**PREVOST**

**WARRANTY BULLETIN**

**WB21-09**

DATE:	September 2021	SECTION:	23 ACCESSORIES
EXPIRATION:	September 2023		
SUBJECT:	<b>INTERFERENCE BETWEEN THE WIPER ARM AND THE WIPER BLADE</b>

Figure 1

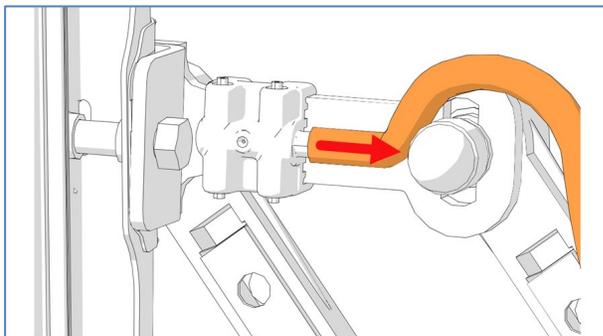
1. On both wiper arm assemblies, disconnect the windshield washer fluid hoses from the nozzles.

Figure 3

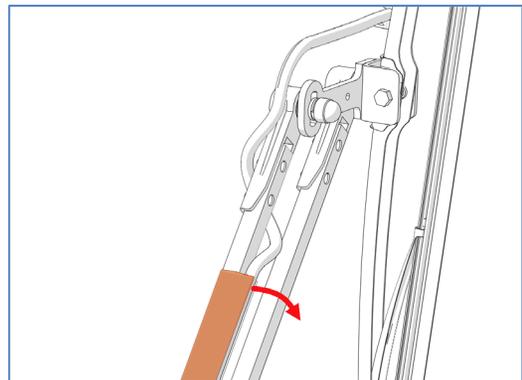
2. On both wiper arm assemblies, detach the hose holders. Take care not to damage the wiper arm paint.

Figure 4 : AS SEEN FROM INSIDE

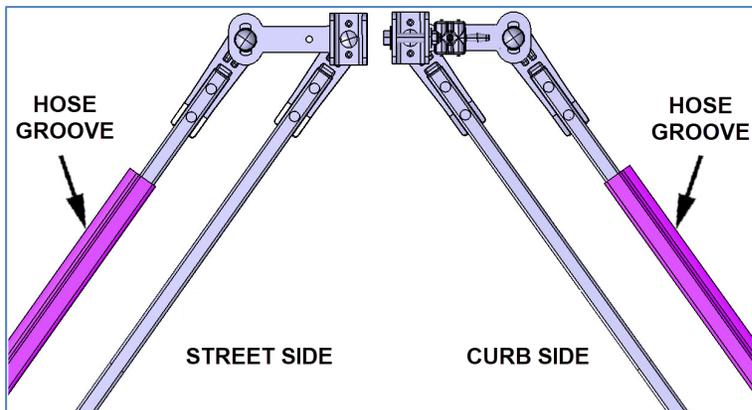
3. Reinstall the hose holder so that the hose groove is located as follows:
  - On the street side wiper arm assembly, the hose groove is located on the street side of the arm.
  - On the curb side wiper arm assembly, the hose groove is located on the curb side of the arm.

Figure 6 : STREET SIDE WIPER ARM

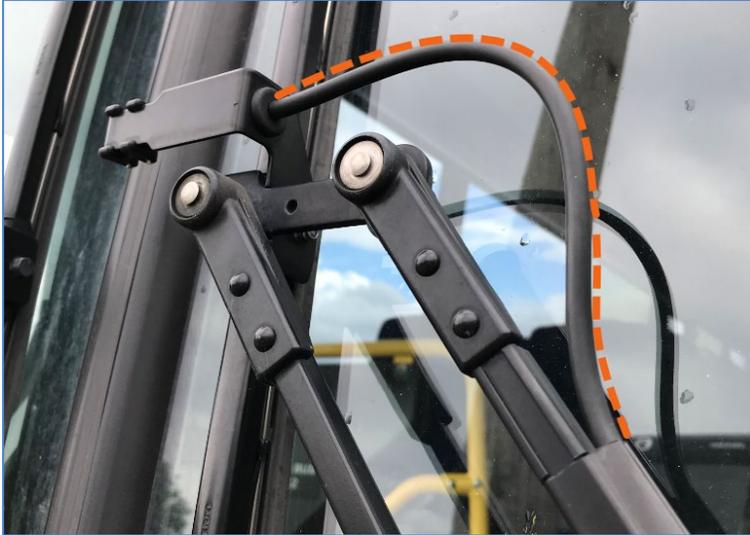
4. On the street side wiper arm assembly, route the windshield washer as shown and connect to the nozzle (Figure 6).
